APPROVED PLAN
CITY OF PUYALLUP
PLANNING DIVISION

CASE NO.: PRSG20220136

Gustafson Insurance
Pemco

Dimensional Channel Letters
Raceway Mounted
LED Lighting

RACEWAY FRONT VIEW

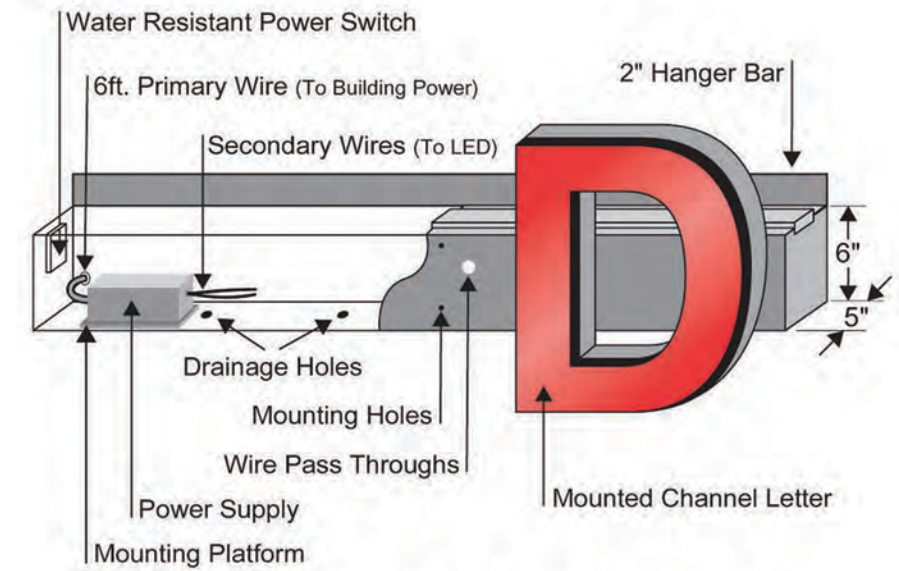
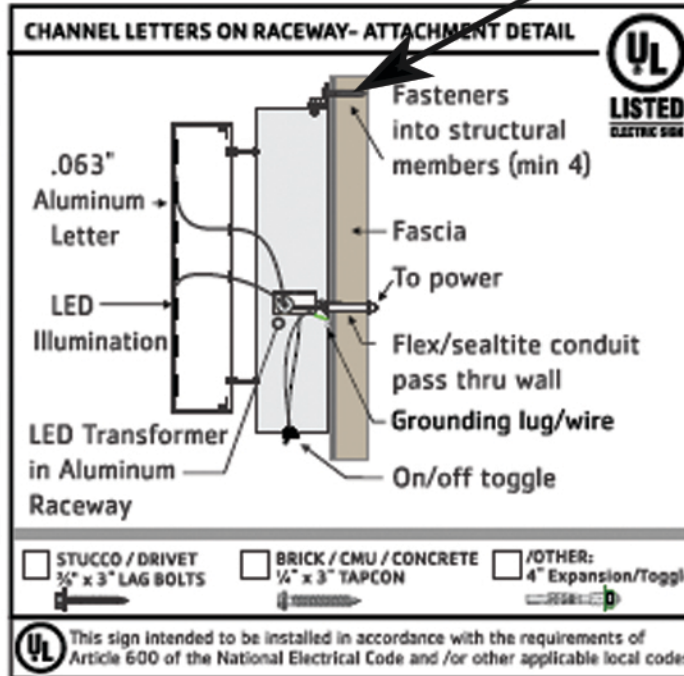
Planning Note: The sign area was measured utilizing two rectangle boxes. The top rectangle box measured 14.67 square feet. The bottom rectangle measured 3 square feet. The total sign area is 17.67 square feet
